From: Lake Forest Neighborhood Association (NA) Board

Lake Forest NA takes the following positions for LU 23-0002 "Request for an RP delineation, Unavoidable RP Crossing, and Serial Lot Line Adjustments.":

Figure 6.14 applies to the subject development:

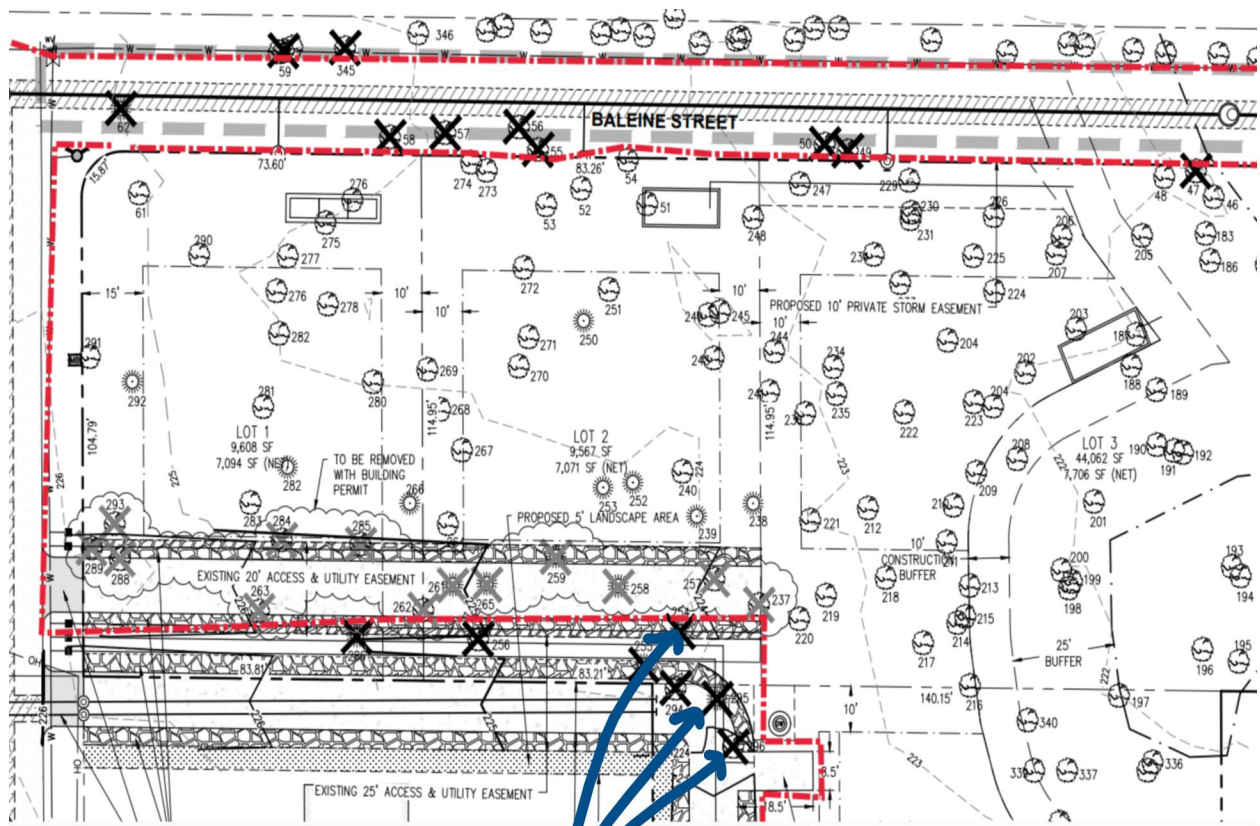
This figure shows the sewer extension proposed by the applicant. Lake Forest NA takes issue with the application of this Wastewater Master Plan Update as a requirement for the applicant's development. This sewer extension for the applicant's development (i.e., pipe alignment) is not logical, not cost-effective and is inconsistent with LOC 50.05.010.6 by requiring an RP crossing. It is Lake Forest NA position that a practicable alternative exists that would be cost-effective and would avoid the RP crossing.

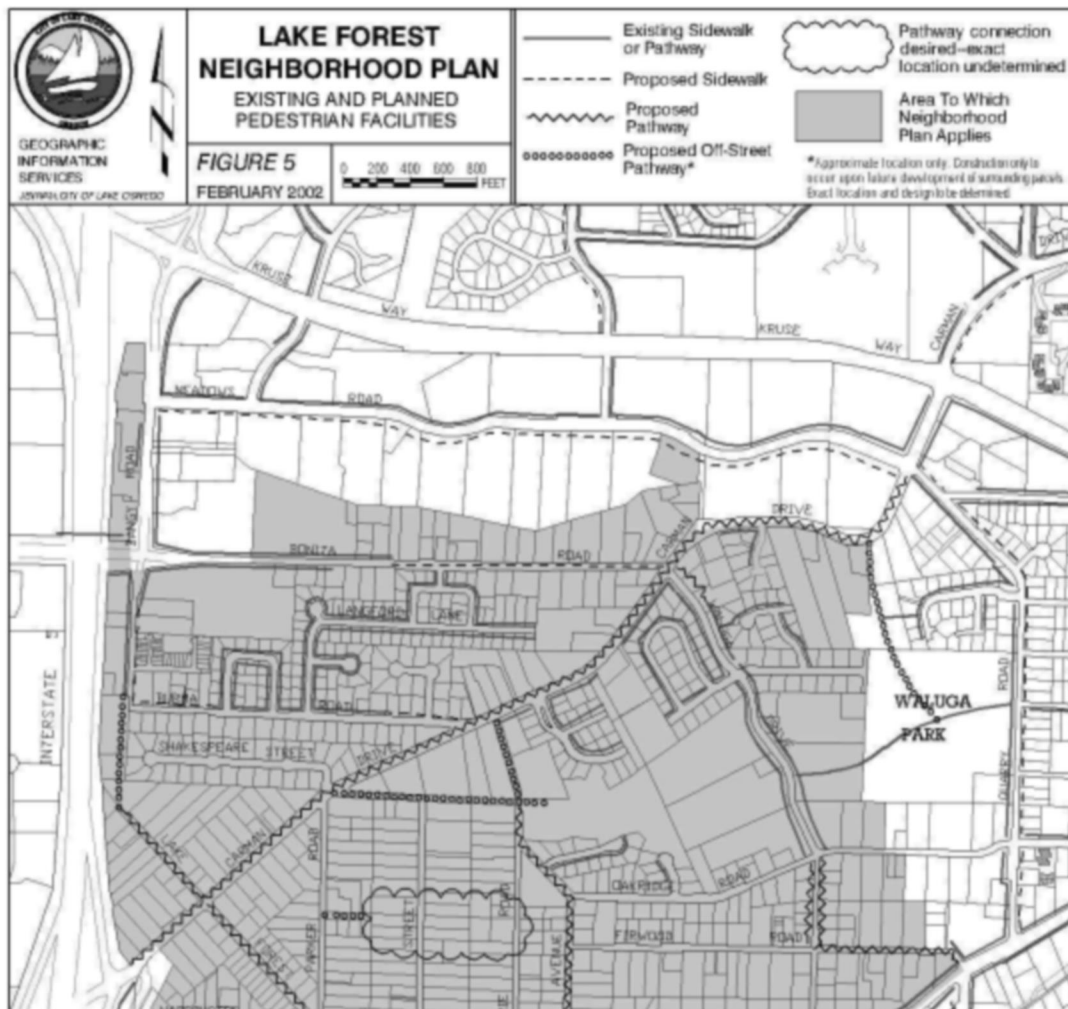
Although written in the double negative, Lake Forest NA reads the bolded excerpt of the preceding paragraph ***to require right-of-way dedication or street improvements to Baleine Street because additional lots are being created with the serial partitioning.***

The existing Baleine Street pedestrian connection between Inverurie Road and Kimball Street through the wetland is well used today, and the proposed development will lead to additional use, as an important east-west pedestrian connection within the neighborhood allowing residents (especially children) a safer route to Waluga Park. This pathway is very important to residents and is included in the Lake Forest Neighborhood Plan. Figure 5 (provided here) of the plan shows a "proposed off street pathway" in this location.

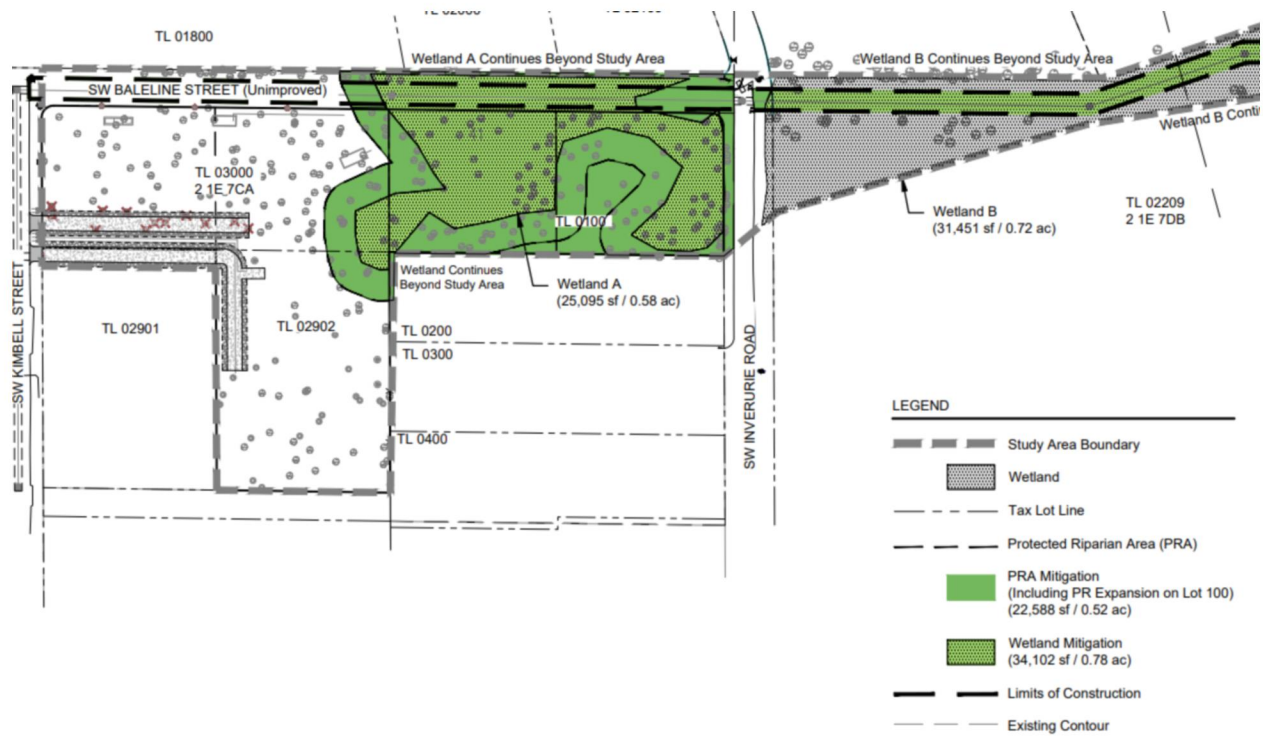
Position 5: Lake Forest NA finds that the PRA and Wetland mitigation on TL 03000 and TL 02902 will substantially impact the placement of future housing on lots 3 and 4, especially lot 3. Prior to approval of the serial lot partitions, the applicant needs to be clear how code obligations will be met with respect to mitigation and building setback requirements without creating conflicts with typical backyard and/or side yard uses by future residents.
